Drury Metropolitan Centre Fast-track

Auckland Council Specialist Memo

**Annexure 9:
Parks Planning
Lea van Heerden
11 August 2025**

Parks Planning Memo

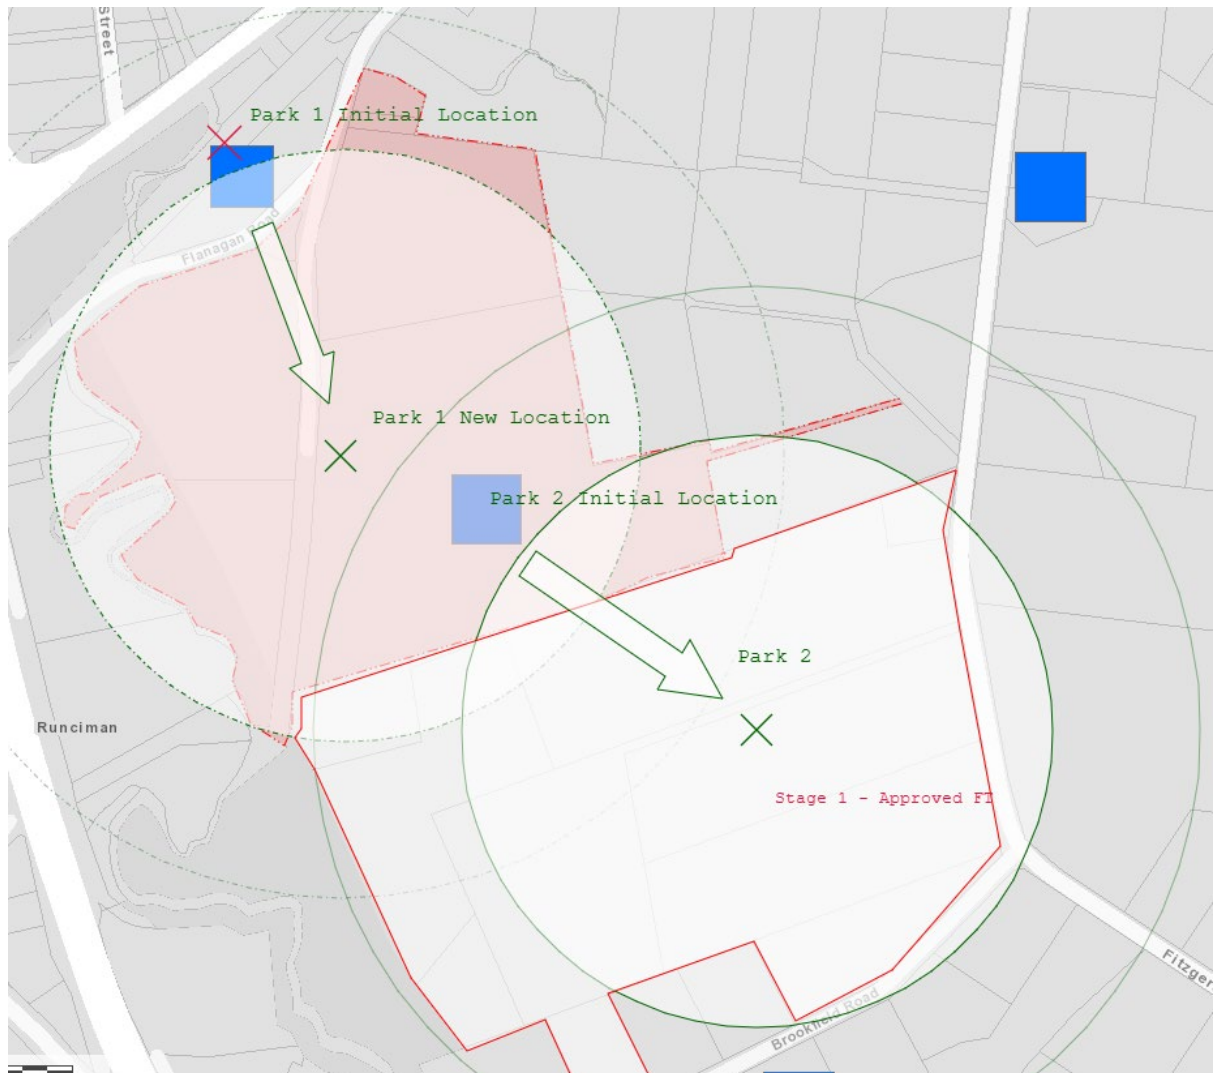
- 4.6. Parks Planning also supports the recommendation for an additional neighbourhood park to be delivered within Stage 2 of the Drury development. While Stage 1 includes a neighbourhood park north-east of approximately 7826m², its catchment does not sufficiently extend to the entirety of Stage 2. Applying the Auckland Council standard 300m walking proxy for medium to high-density development (with 400m typically used for lower density), significant portions of Stage 2 remain unserved.

- 4.7. There is strong spatial logic and strategic justification for introducing a new neighbourhood park to be located centrally in Stage 2, in proximity to the drainage reserve and along the

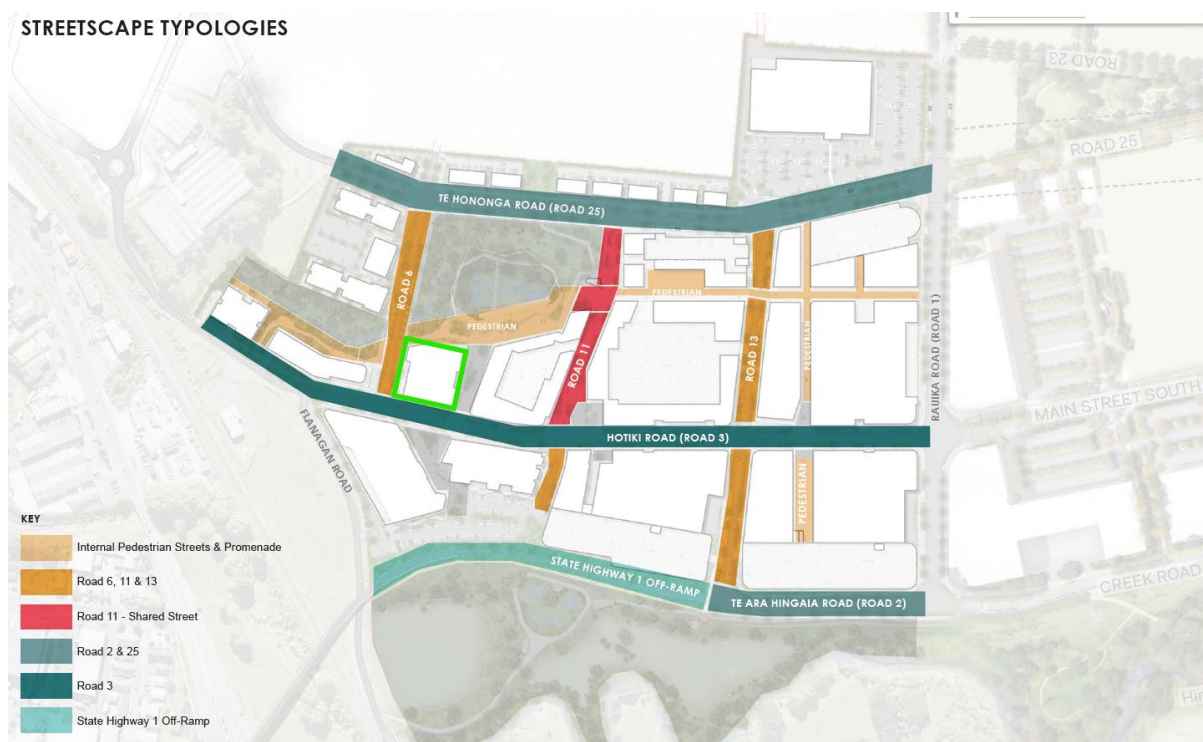
- 4.12. To address this gap, Council recommends the inclusion of an additional flood-free neighbourhood park within Stage 2, with a minimum size of 3,000m². The preferred location is within Stage 2.6.2, specifically in the north-western corner of Lot 36, situated between Lot 500 (Road) and Lot 512 (Road). Lot 36 has a total area of 11,401m², and it is considered both feasible and appropriate that 3,000m² of this area be secured and offered as land in lieu of a recreation reserve. This would meet Auckland Council's Open Space Provision Policy (2016) for metropolitan centre zoning and deliver land that is unencumbered, accessible, and capable of accommodating formal recreation infrastructure. The recommended location would also strengthen the east-west pedestrian connection between the esplanade reserve and the stormwater wetland via the proposed promenade, while supporting civic functions and community activities currently unaddressed within the development.

- 4.20. A new flood-free, publicly accessible neighbourhood park of no less than 2,000- 3,000m² should be secured within Stage 2. This park should:
- a) Be located centrally adjacent to the Stream A corridor and the 2.6ha drainage reserve to maximise network integration;
 - b) Support informal recreation and formal asset development (e.g. play, courts and social infrastructure) in a distributed manner across the site;
 - c) This park should be unencumbered, capable of supporting a 30m x 30m kick-about space, and preferably located on flat land ($\leq 3\%$ slope) with strong street edge visibility to ensure accessibility for all users.
 - d) Be designed to meet the Manaaki Tāmaki Makaurau – Auckland Open Spaces, Sports and Recreation Strategy (2025) proximity target of 300m for medium to high-density areas.
